Special Bulletin

SP15-339

CURB SIDE FLOOR NOSING HARDWARE

Prevost vehicles

Figure 1

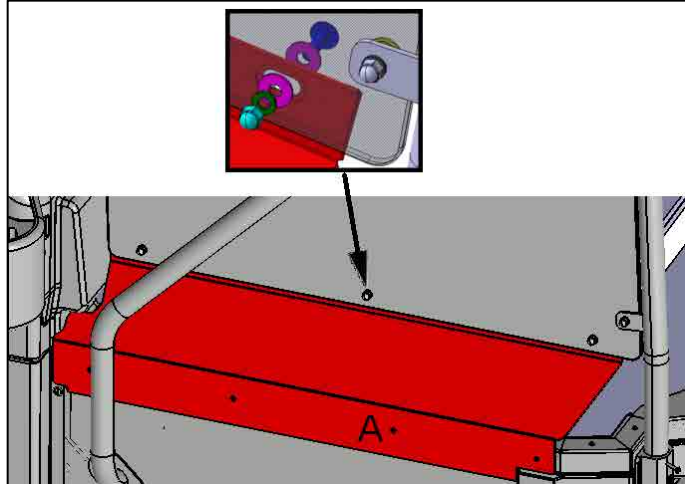
1. Remove the kick plate. To access the step nosing.

Keep modesty panel hardware (Fig. 1).

Part number reference:

Screw	5001871 qty 3
Flat	500411 qty 9
Lock	500477 qty 3
Cap	500772 qty 3

Figure 2

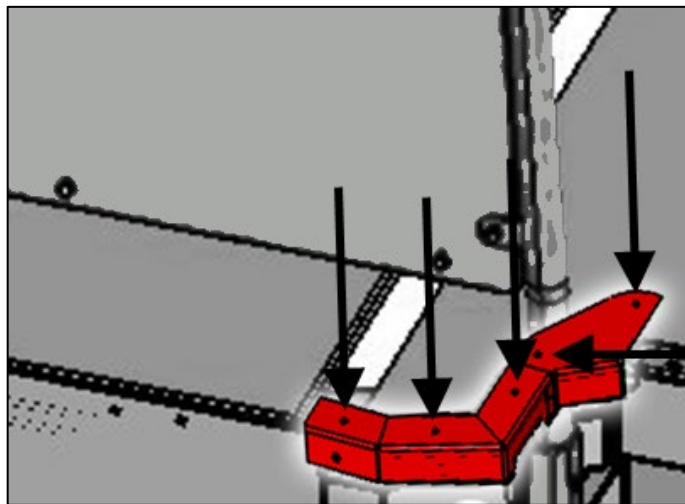
2. On the step nosing, install new replacement hardware 5x 5001119, at indicated locations. (Fig. 2)

Figure 3

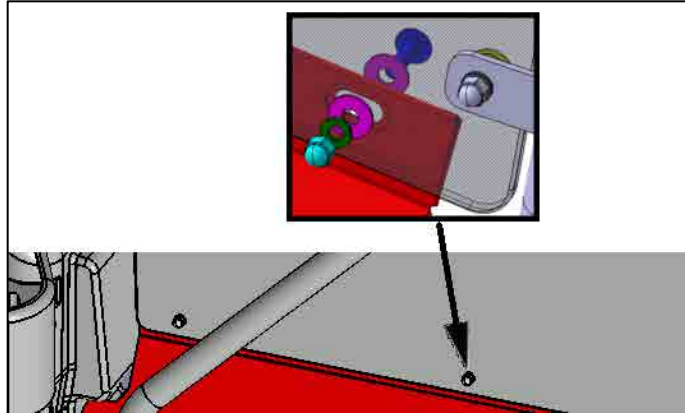
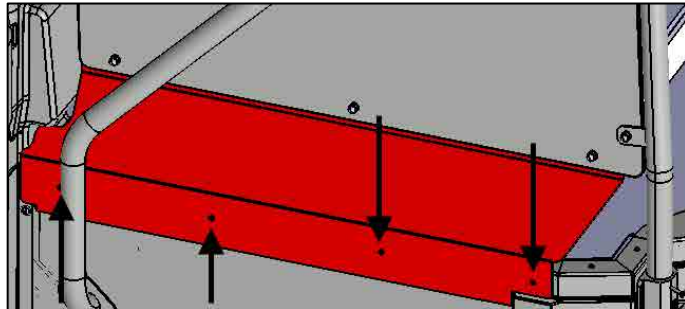
3. Install the kick plate back on the modesty panel using hardware reserved previously.

4. Install new replacement hardware 5001119, qty 4 at indicated locations.
